Clerk of the Local Review Body  
Council Head Quarters  
Newtown St Boswells  
Roxburghshire  
TD6 0SA

**Reference: 20/00018/RRREF**

**Figure 1: Effect on ridge height from inaccurate building measurement.**

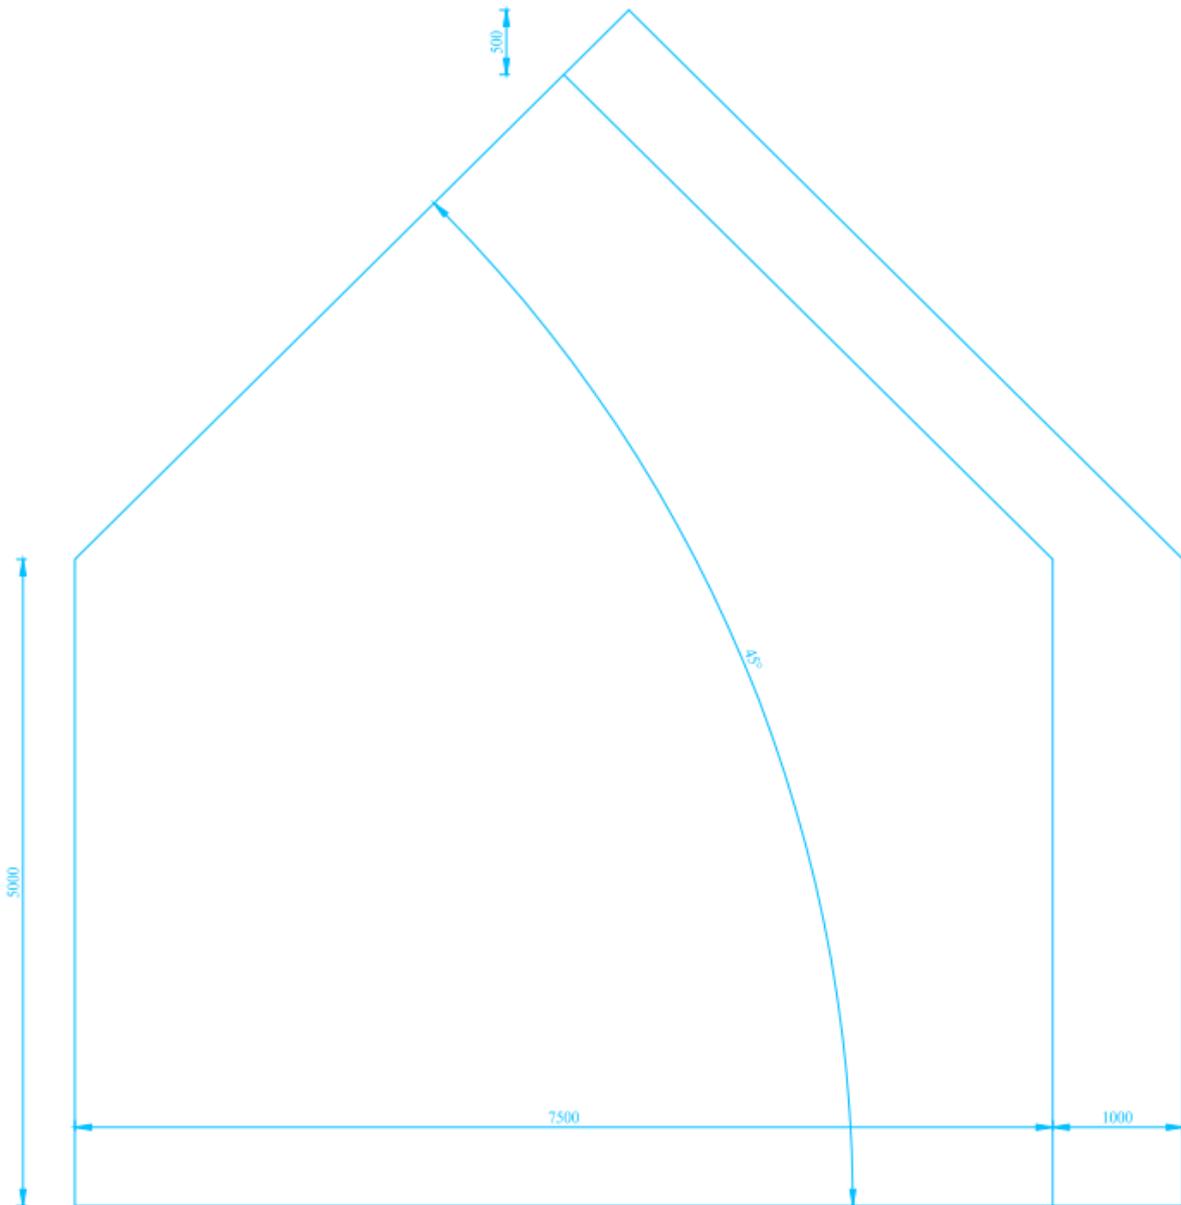
width, taken from the mapping software, and plots against it the height of the eaves and assumes the roof pitch, a ridge height can be calculated. If, however, that building width is inaccurate, +/-1m, there is potential for significant error in the ridge height calculation, Figure 1.

**Figure 2: Effect on ridge height from inaccurate pitch measurement.**

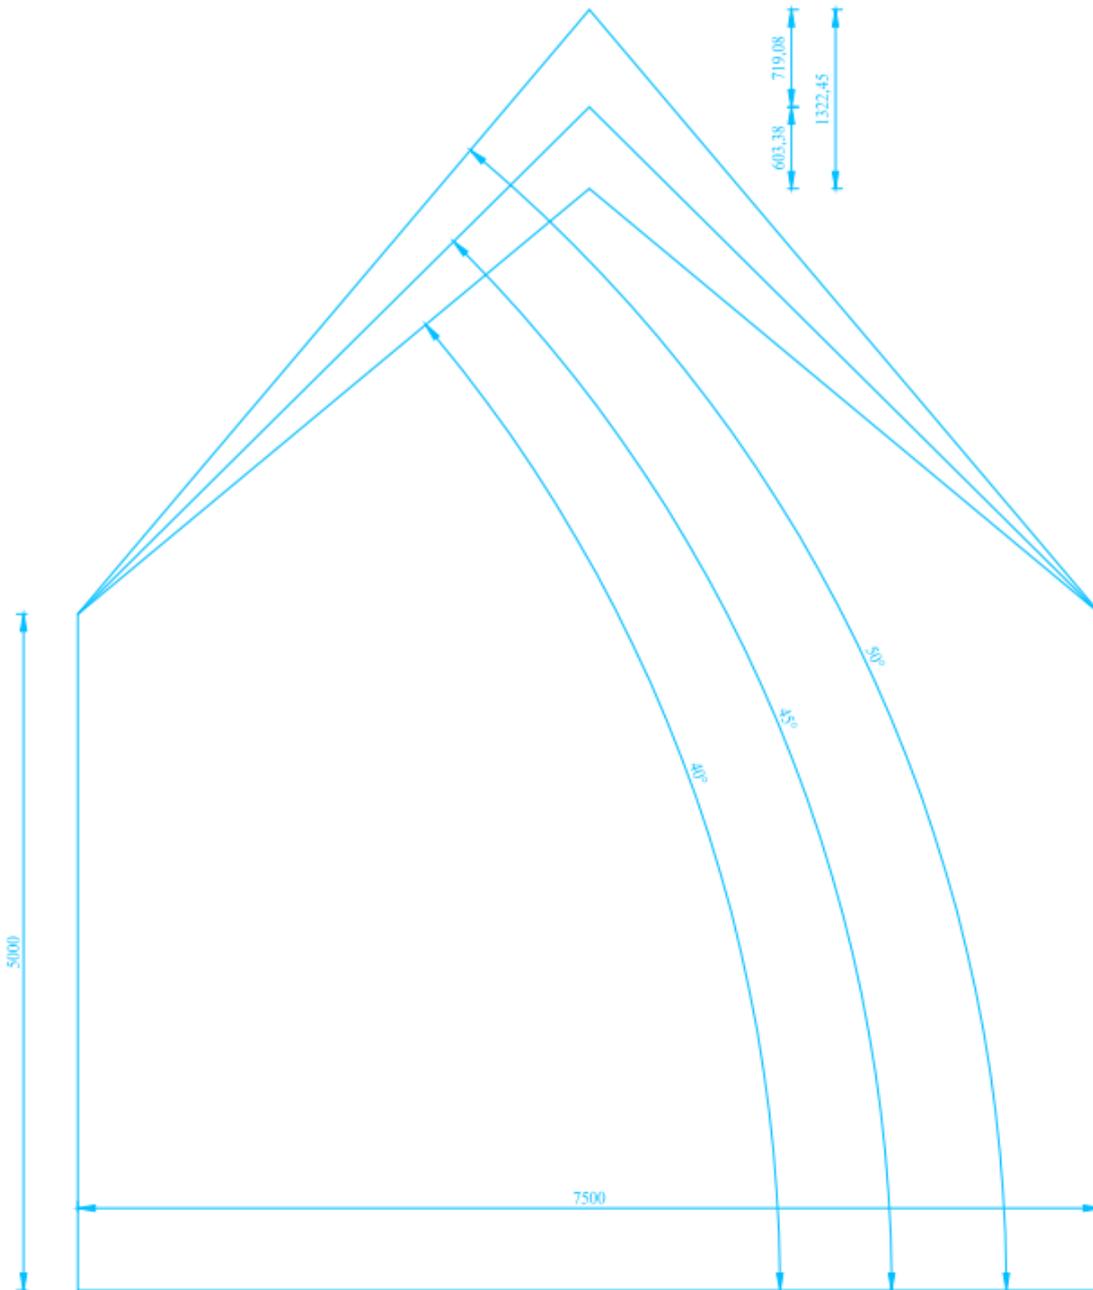
In addition to the above, without actually measuring the pitch of a roof, then it is impossible to know their true pitch and impossible to calculate the ridge height with any degree of accuracy or certainty. Perhaps with the exception of Clifton Cottage, there is nothing confirming any other roof has had their pitch measured. Therefore, ridge heights shown in the submission are no more than conjecture. It's true the majority of rooves locally vary between 40° and 50° but without measurement, there is potential for a significant margin of error, Figure 2.

**Figure 3: Poor practice in correlating physical measurement to GPS elevations.**

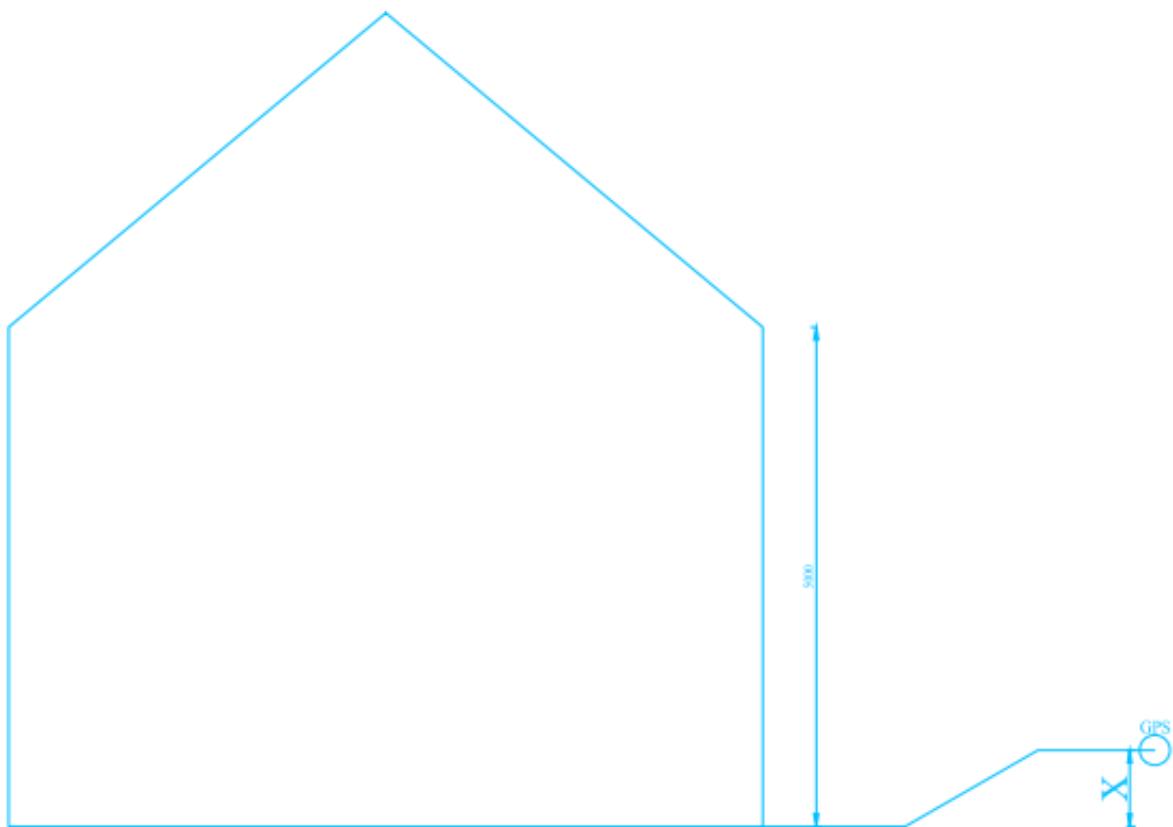
The location at which GPS measurements were taken also raises some concern. There is no plan of where GPS readings have been taken so it is impossible to know how they correlate to any physical measurement undertaken. It is noted in the applicant's representation dated 28<sup>th</sup> Aug that the property to the north had the eaves measurement taken and then that measurement was plotted against a GPS elevation reading taken on the nearby public road. This is poor practice and if this is representative of the way in which other measurements have been taken and plotted, it causes grave concern for the accuracy of the information. Figure 3 demonstrates the significant potential for error by the unknown size X.
